PLANNING AND ZONING COMMISSION AGENDA

**Planning and Zoning Commission Public Hearing
Thursday, OCTOBER 20, 2020
6:00 p.m.**

Case 1809-Z/Baumann Building. Discussion, and take action on a recommendation regarding an ordinance changing the zoning on a .57-acre property located at 4901 Arapaho Road, which property is currently zoned PD, Planned Development, through Ordinance O04-048, by approving a new PD district, to allow a 5-story mixed use building.

RE: Case 1809-Z/Baumann Building
LOCATION: 4901 Arapaho Road
REQUEST: Approval of an ordinance changing the zoning from Planned Development (PD) district, through Ordinance O04-04, to a new PD district to allow development of a five-story, 41,388 square-foot multitenant commercial building with one residential unit on the top floor.
APPLICANT: Daniel Anderson, Trium Development Partners, LLC

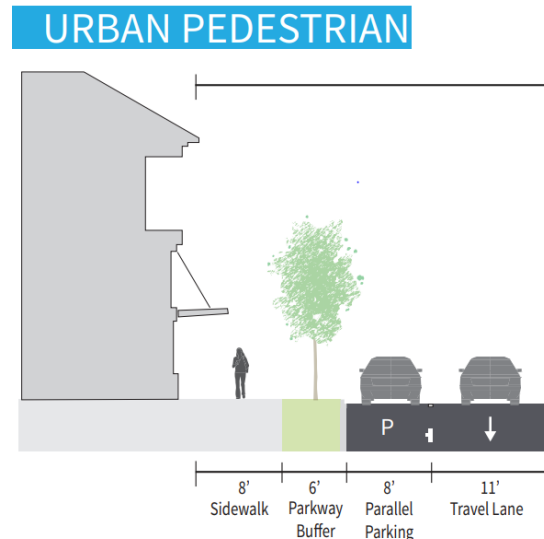
Streetscapes: The Master Transportation Plan provides streetscape standards for various street types. Arapaho Road is defined as a Minor Arterial. The existing sidewalk along Arapaho Road has already been constructed with a specific look that runs the length of the corridor and no changes are being proposed or required by Staff.

The Master Transportation Plan defines Edwin Lewis Drive as a Commercial Collector street and provides three options for such streets to be applied based on the context of the surrounding development. Given the desire to integrate future development in this area with the existing character of Addison Circle, the Urban Pedestrian standard is most appropriate for this property. As shown in the image below, this would require an 8 foot on-street parallel parking area, a 6 foot parkway buffer with street trees, and an 8 foot sidewalk.

This is the standard that was applied to both AMLI and Western International. The applicant's plans for the redevelopment of the streetscape along Edwin Lewis Drive meet the urban pedestrian standards laid out in the Master Transportation Plan.

1 Conceptual Site Plan
Scale: 1" = 10'-0"

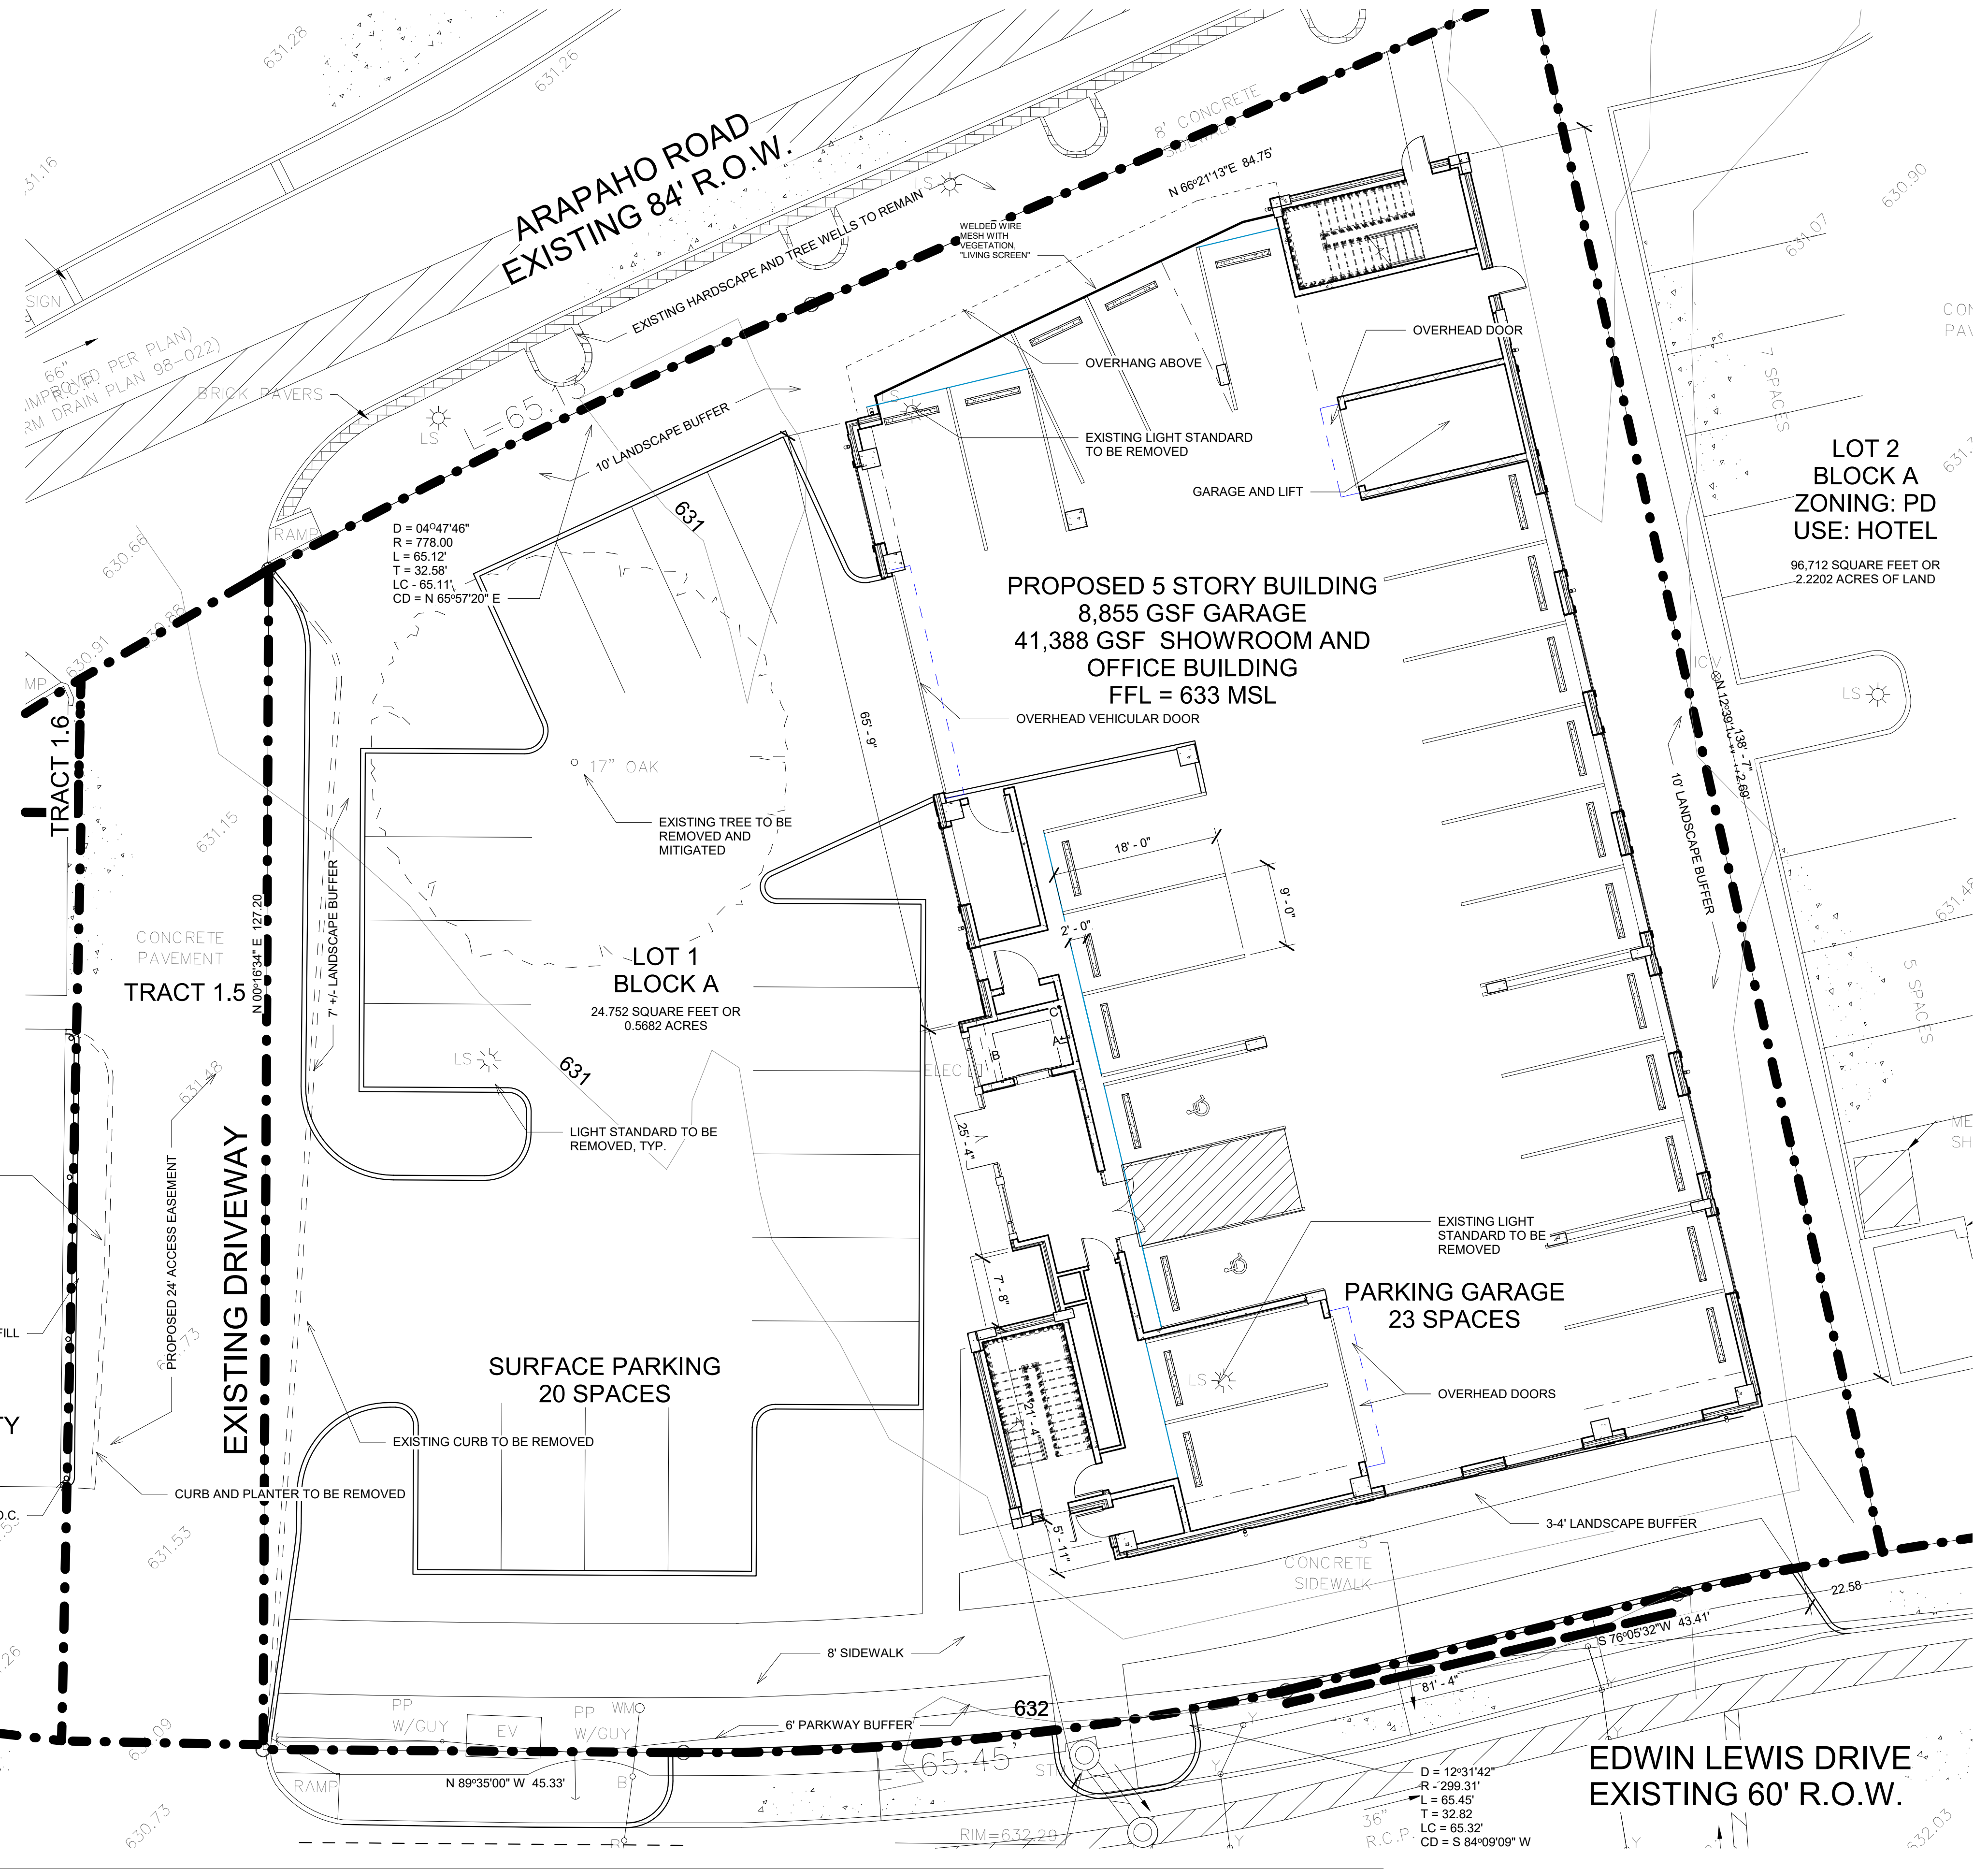
Building Setback: The Urban Center standards typically require that buildings be set back 10 feet from the edge of the sidewalk, which in Addison Circle is the property line. The plans show the setback would meet this 10-foot requirement along Arapaho Road and Edwin Lewis Drive.

The proposed plan only provides a total of 46 onsite parking spaces. This is 35 spaces short of the Town's typical requirements, and even 4 spaces short of the applicant's proposed calculation method. The applicant's request for only counting usable square footage excludes the balconies on each floor. If the balconies are counted as usable square footage the development would require 53 parking spaces and the plan would be 7 spaces short of meeting requirements. **The applicant is requesting that the parking requirements be calculated based only on useable square footage of the building, that the clothing store be parked at a showroom ratio, and that the property be given relief on the additional 4 parking space based on the property being located near the future DART rail station.**

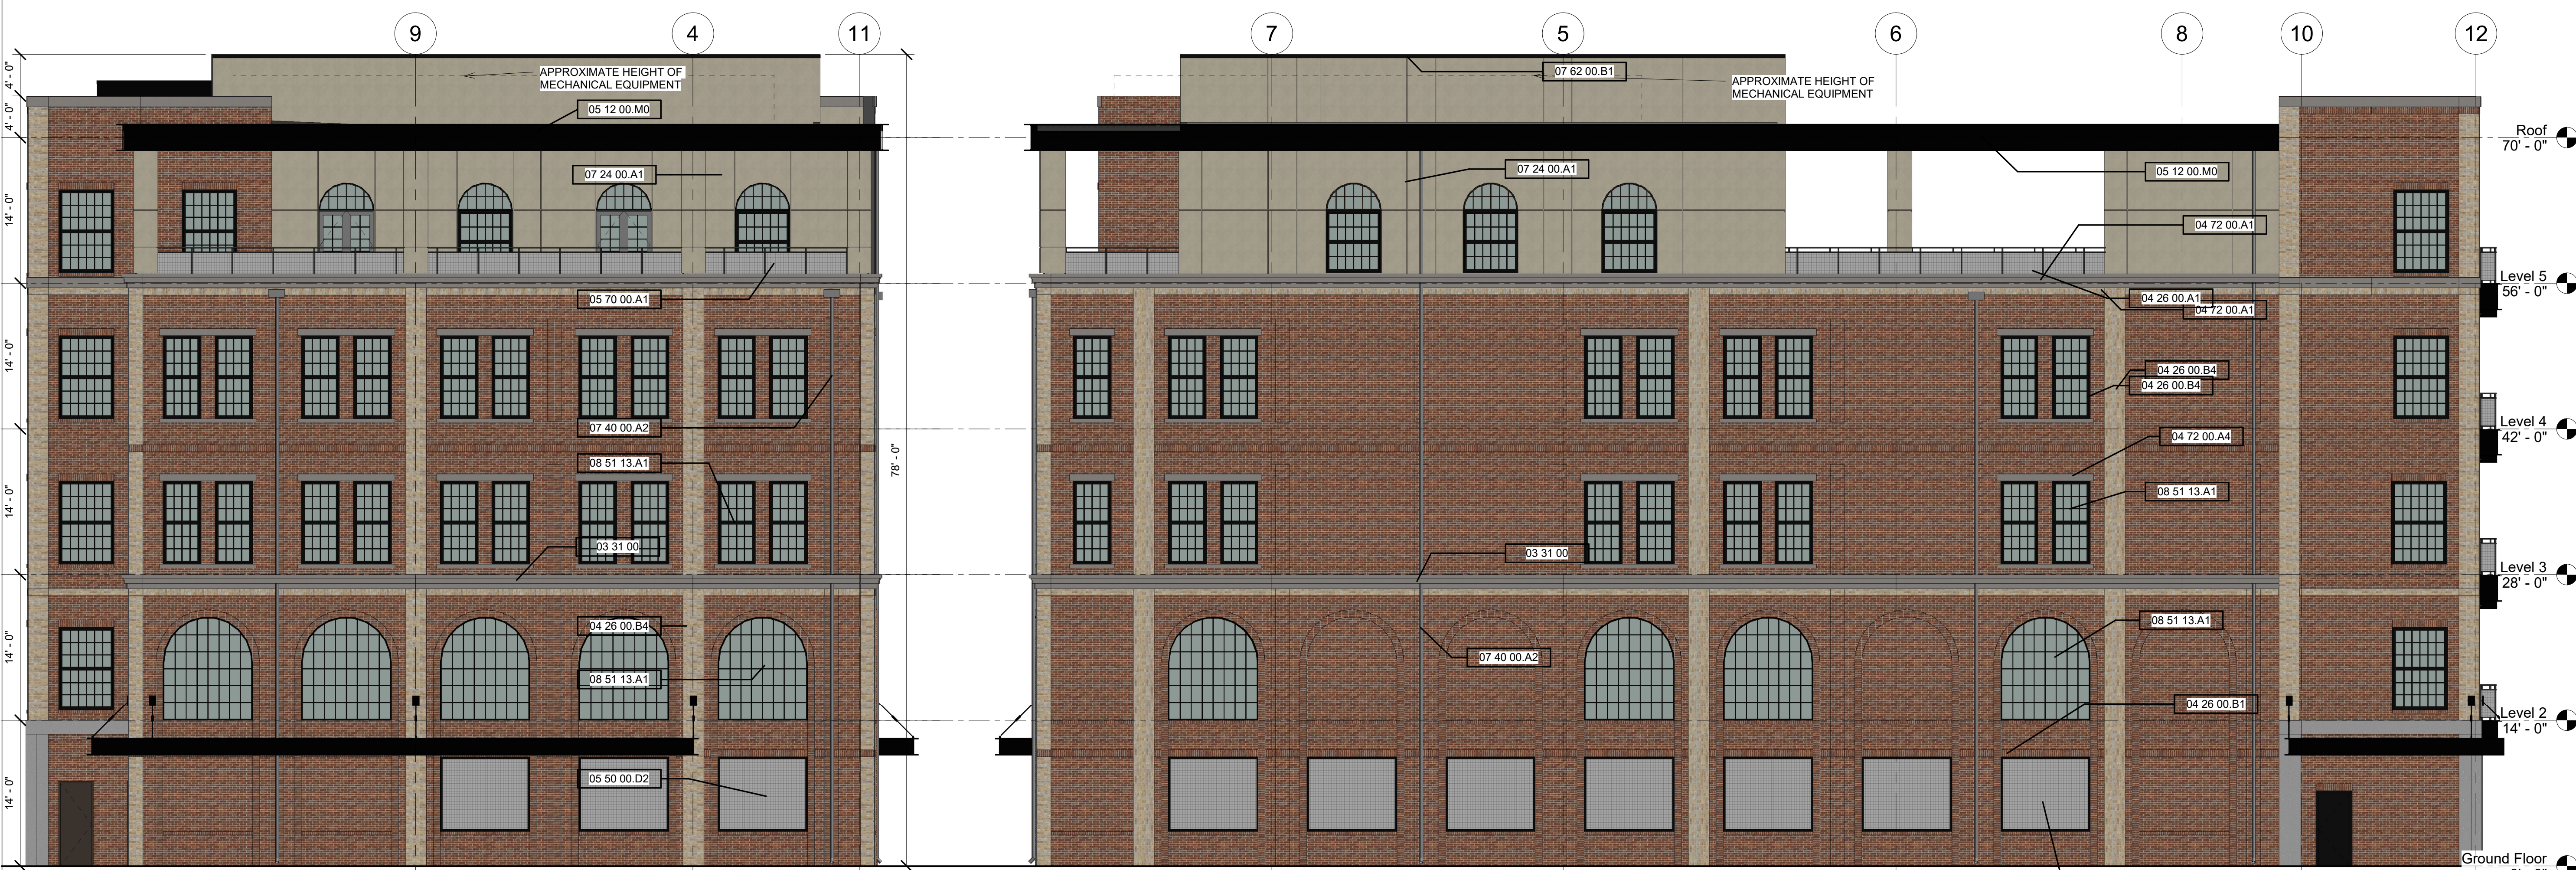
Building Elevations: Urban Center standards require building facades to be a minimum of 90% brick or stone, however, provided the recent passing of House Bill 2439, Staff is unable to enforce the exterior materials requirement at this time. The plans show the south and east elevations at approximately 75% brick and cast stone, and north and west elevations at approximately 50% brick and cast stone, with the rest of the façade being constructed of painted metal, EIFs, exposed concrete, and ACM panel.
